UNITED STATES PATENT AND TRADEMARK OFFICE

APPLICATION NO.	FILING DATE	FIRST NAMED INVENTOR	ATTORNEY DOCKET NO.	CONFIRMATION NO.
09/811,326	03/16/2001	Larry W. Fullerton	ALER1460	7179

Office Action Summary	Application No. 09/811,326	Applicant(s) FULLERTON ET AL.	
	Examiner Betsy L. Deppe	Art Unit 2611

FIG. 26

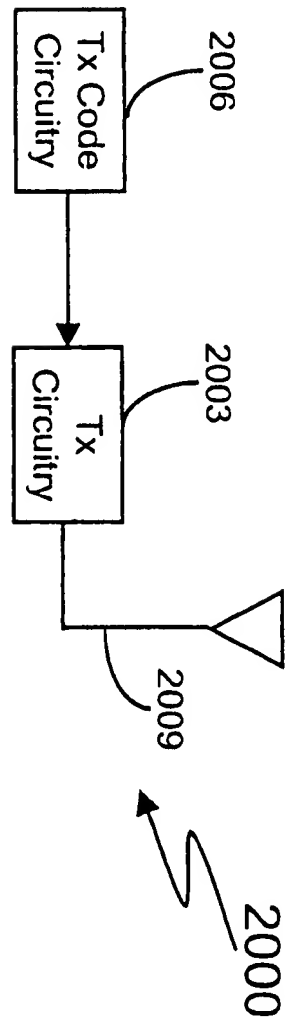
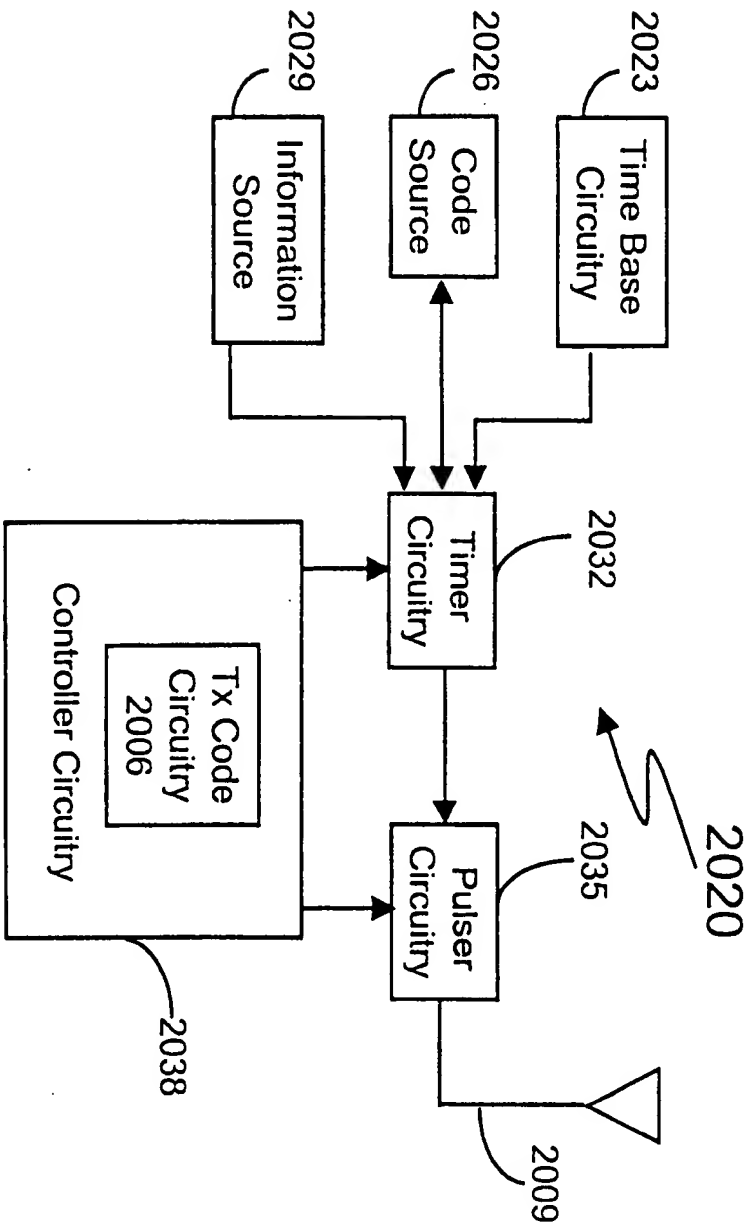
Acceptable
B3D
